**RE: Amendment to FCC File No. BMML-20161222ABW
FCC 302-AM Application for Modified Broadcast License
Utilizing Moment Method Modeling
KDIA(AM), Vallejo, CA (FCC Facility ID #87108)**

This amendment is submitted to address the deficiencies outlined in the attached March 30, 2017 letter from Son Nguyen, Supervisory Engineer, Audio Division, Media Bureau.

The firm of Hammett & Edison, Inc., Consulting Engineers, has been retained by Baybridge Communications, LLC, licensee of Radio Station KDIA, 1640 kHz, Vallejo, California, to prepare the engineering portion of an application for modification of license of its nighttime operation.

Antenna System

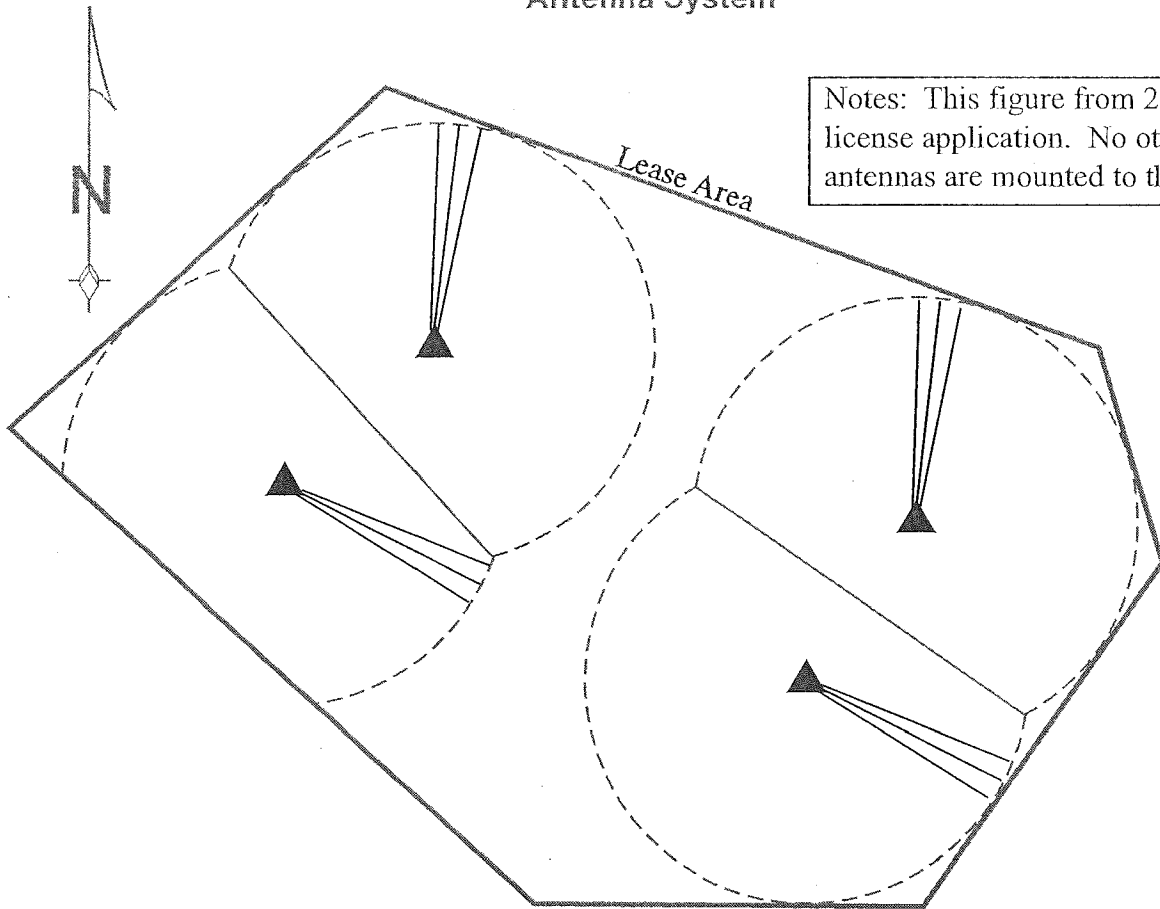
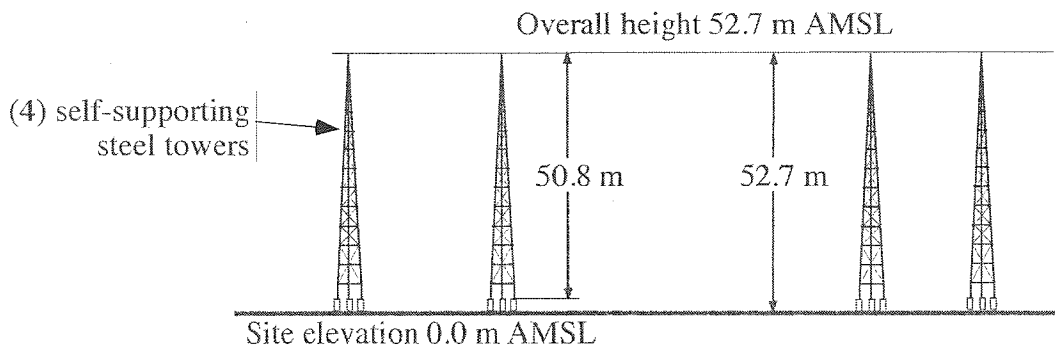
1. The assumed average radius for the tapered antenna structure should be 0.437 meters (0.218 meter (top radius of tower) + 0.655 meter (base radius of tower)/2) for the entire tower when using the method of moments model. You incorrectly modeled the tower with a wire radius of 1.2 meters citing Section 73.151(c)(1)(i). Section 73.151(c)(1)(i) is not applicable since it refers to tolerance from the actual radius of the tower, not an assumed radius.

- The four-tower KDIA nighttime array consists only of series-fed elements, arranged as shown on the attached Figure 1 (from the 2008 proof-of-performance).
- The lattice towers are tapered, with their faces 4.5 feet across at the base and 1.5 feet at the top. The radius of a circle whose circumference is equal to the sum of the tower faces is 0.655 meters at the base and 0.218 meters at the top. Their arithmetic average (0.437 meters) is the wire radius used in the model.
- The 50.8-meter towers are electrically 100.0° tall at the 1640 kHz frequency of operation. Each tower is represented by 13 wire segments, so at the start of the MOM model calibration, described below, each segment is 7.7° tall, below the 10° maximum allowed.
- Base calculations were made for a reference point at ground level.

GEOMETRY						
Wire coordinates in degrees; other dimensions in meters						
Environment: perfect ground						
wire	caps	Distance	Angle	Z	radius	segs
1	none	0	0	0	.437	13
		0	0	111.1		
2	none	82.9	227.5	0	.437	13
		82.9	227.5	111.0		
3	none	207.7	110.1	0	.437	13
		207.7	110.1	109.7		
4	none	202.8	132.	0	.437	13
		202.8	132.	109.9		
Number of wires			=	4		
current nodes			=	52		
			minimum	maximum		
Individual wires	wire	value	wire	value		
segment length	3	8.43846	1	8.54615		
radius	1	.437	1	.437

170824
Figure 5

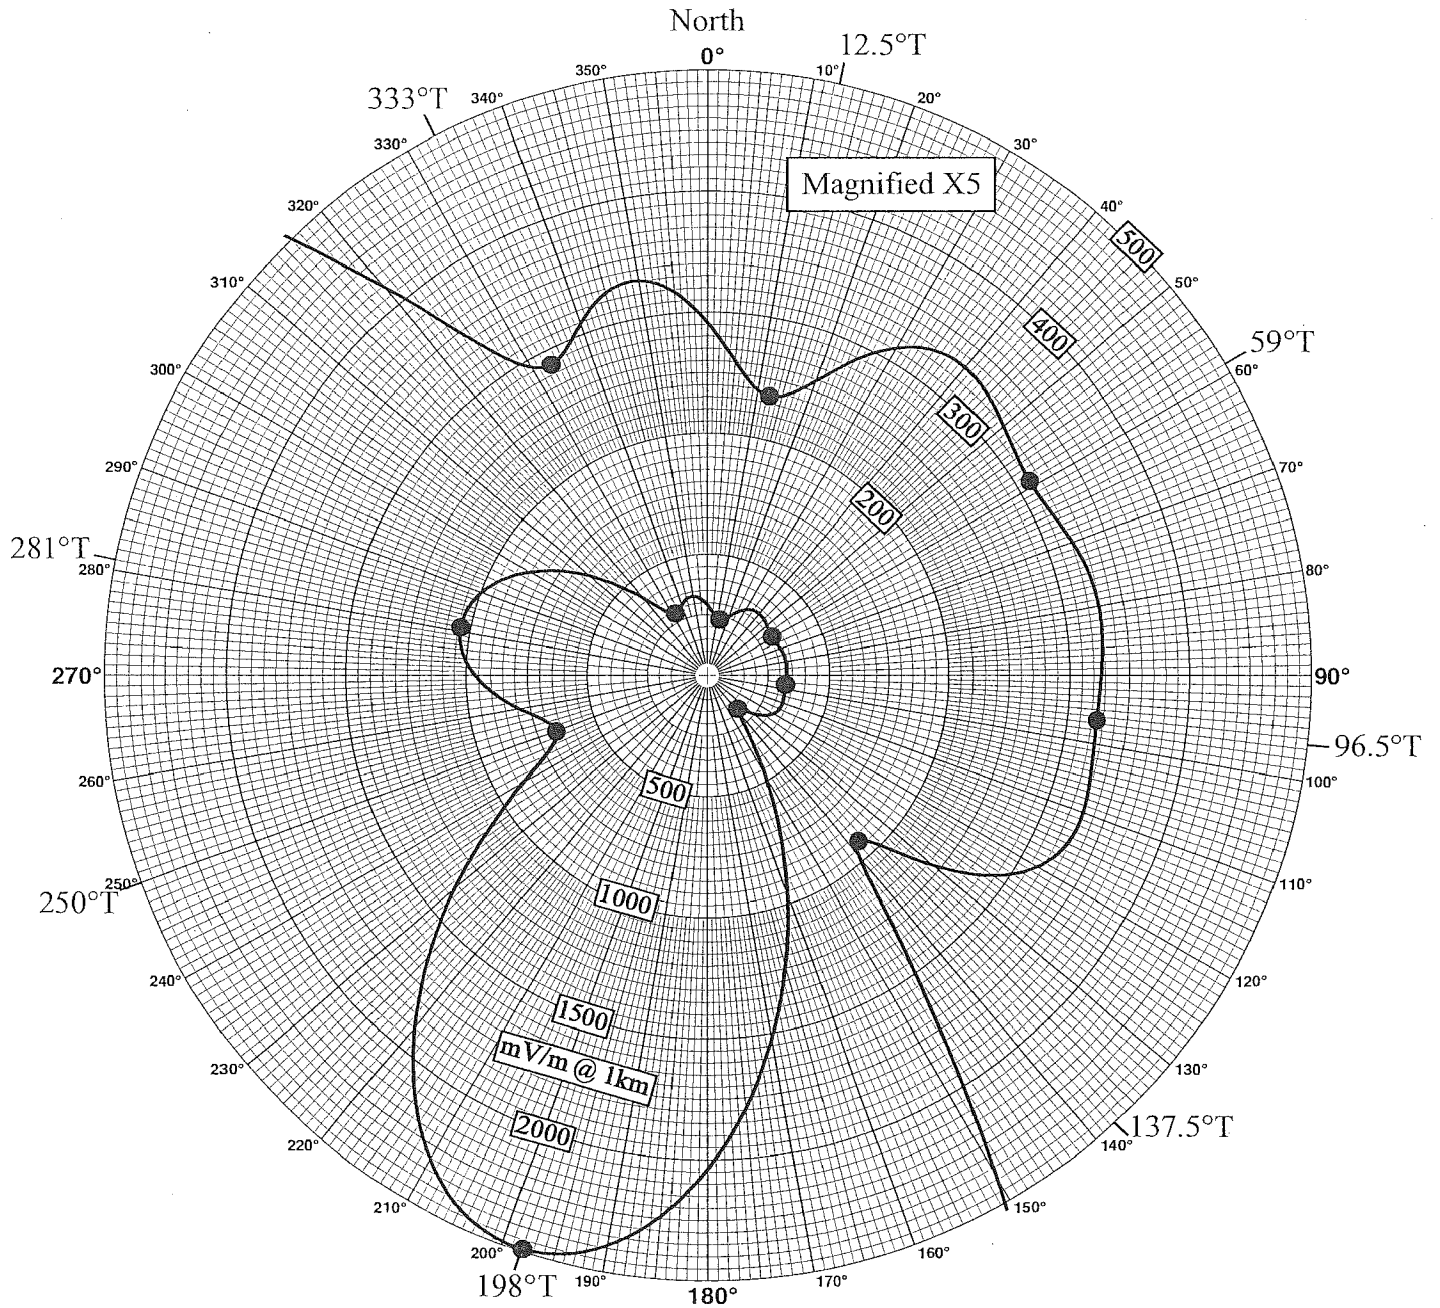
5. We were unable to confirm the nighttime operating parameters from your summary page. Please provide a detailed analysis which includes the array synthesis, the drive impedances and the currents on the tower.

The array has been adjusted to these values, and the reference point measurements required by FCC Rules §73.151(c)(3) were conducted on August 14, 2017, in the directions shown on Figure 5, and are summarized for later reference in Figure 6.

Nighttime Standard Pattern Showing Reference Point Radials
